Project Name: Nuneham Solar Farm

Report Name: Response to Flood Risk & Drainage Objections

Project Number: P21-2947

CLIENT:
RES Ltd

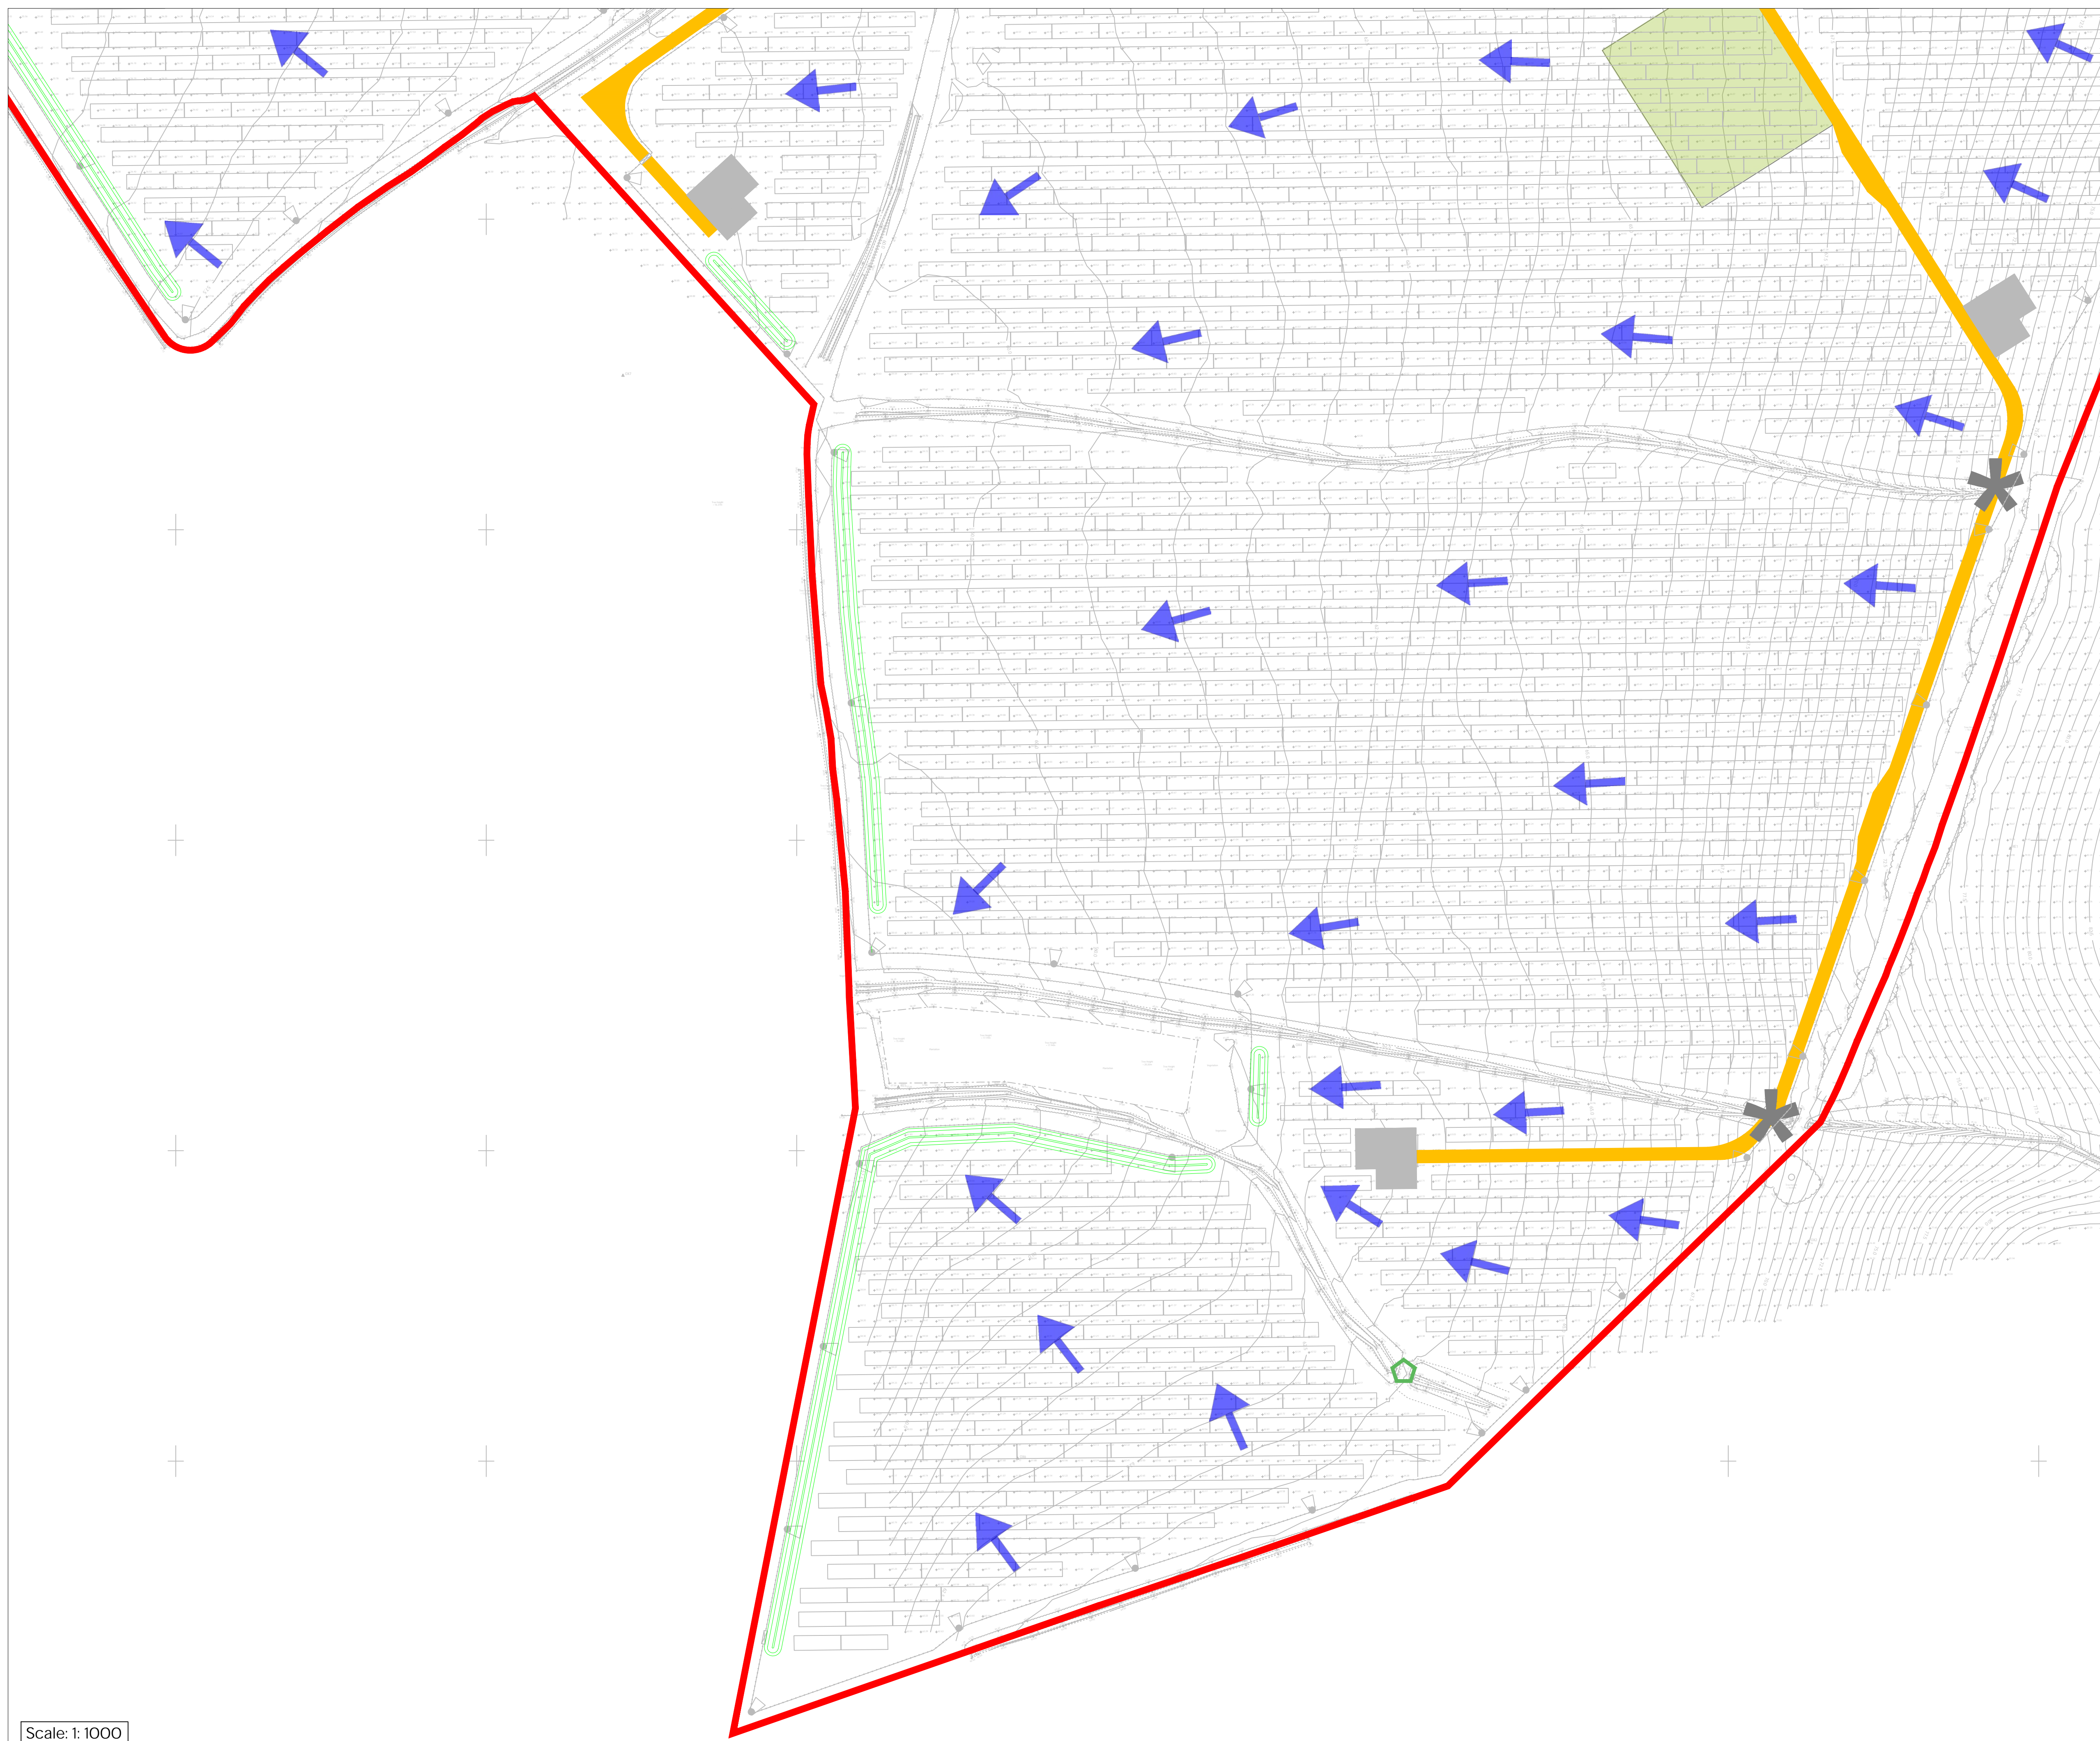
Swales have been discussed within the text to drain access tracks, but no reference to these on the drainage strategy drawing is provided.

All access tracks on site will have a swale alongside them. A typical access track detail for the site is enclosed at the end of this report. It’s noted on this enclosed plan (Figure 6), in reference to the swales, that “actual requirements” will be “determined during detailed design”. In addition to the typical access track detail enclosed at the end of this report, a “Proposed Swales” plan has also been prepared and is enclosed at the end of this report. This plan highlights the access tracks across the site where swales will be provided. The plan also shows several additional swales proposed on site where it has been identified there was not an access track and associated swale at the downslope end of blocks of solar arrays. The proposed swales will help capture and infiltrate and surface water runoff from the site.
